OLD CREEK SQUARE A SUBDIVISION OF LOT 5G SITE PLAN

BY CITY OF NAPOLEON

OLD CREEK SQUARE SUBDIVISION OF LOT 5G	
SITE PLAN	
SCALE: 1"=20'	DATE: 10/01/03
BRYAN ENGINEERING & SURVEYING ANTHONY H. HOEFFEL 128 S. LYNN ST. BRYAN, OH 43506 1-419-636-2060	
1	1

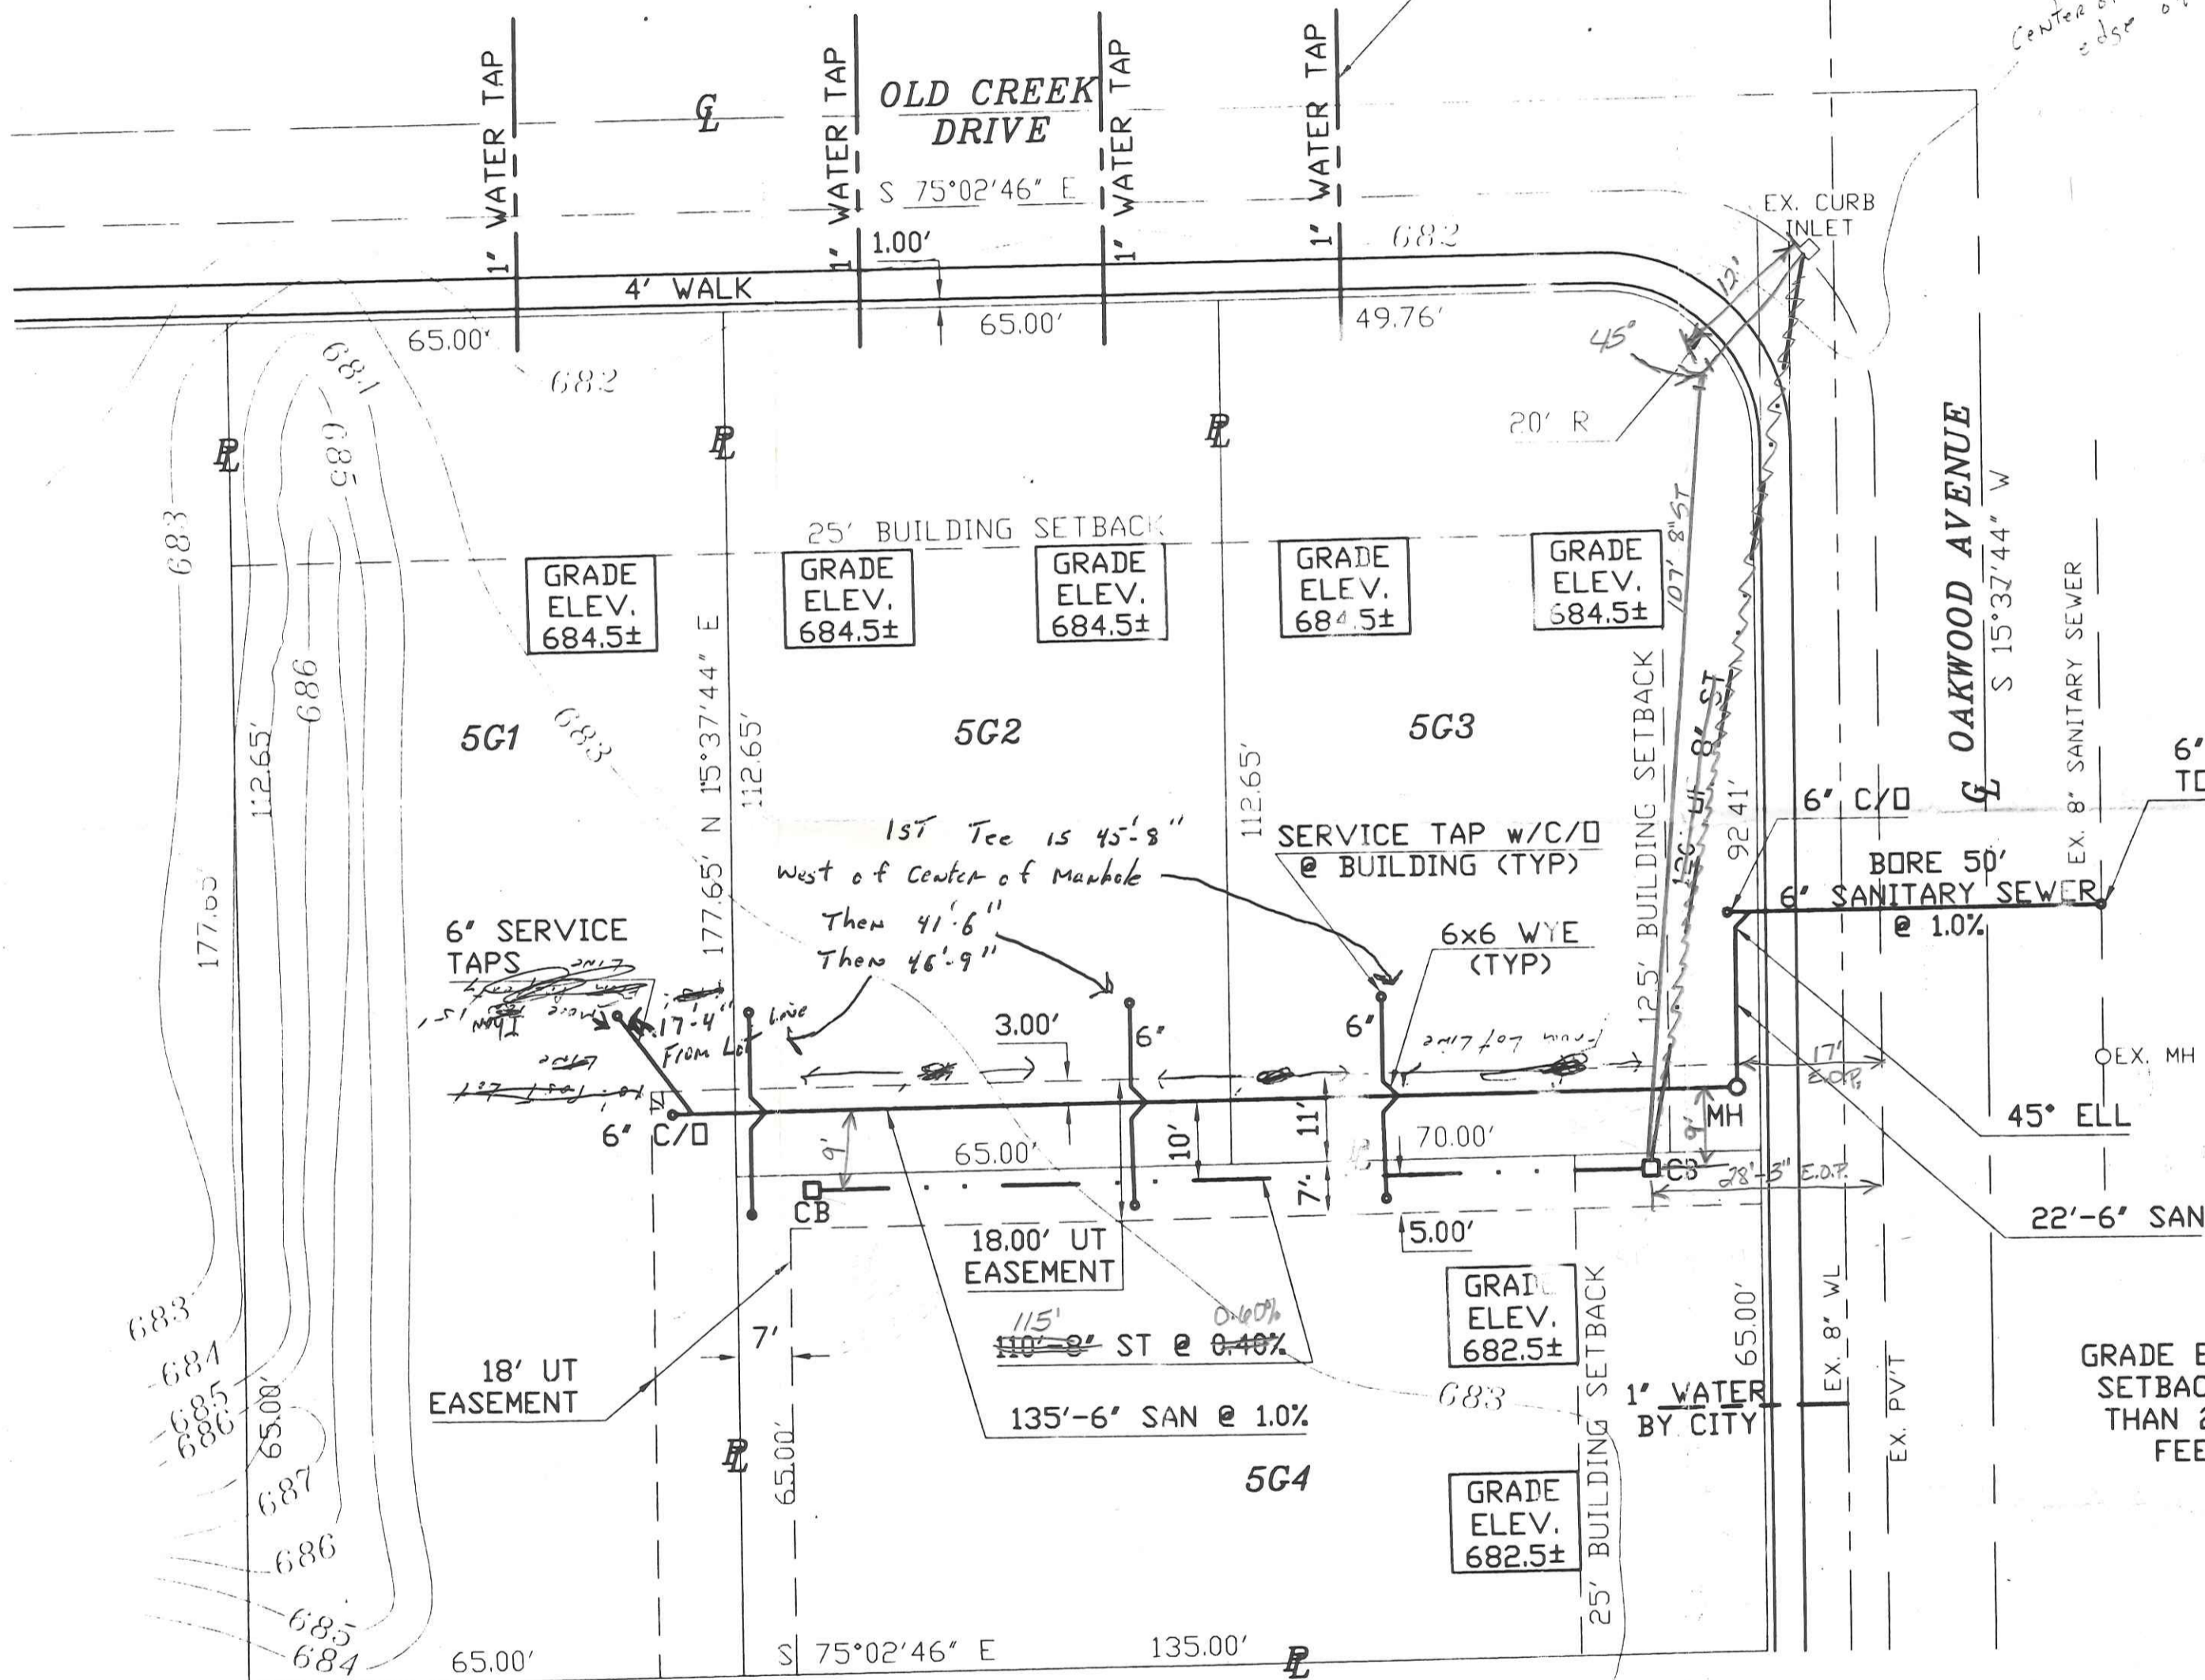
Electric + Gas is OK for Storm Sewer at Curb + Whole Distance

Water Main is between sidewalk & curb, may be in way of catch basin. Water main is on East side of catch basin out of way.

There should be no utilities in way of storm sewer.

Can be 40" deep at 1st Basin with 4" Fall on Tile

Cut Hole 41" from Top of Basin or 3" from floor of Basin to Bottom of hole

Cut Hole in 2nd Basin 7" from Floor Bottom up To Bottom of hole

1st Basin 3" Below Sidewalk Center of Basin 15' from edge of Sidewalk

Handwritten notes:
18" UT Easement
135'-6" SAN @ 1.0%
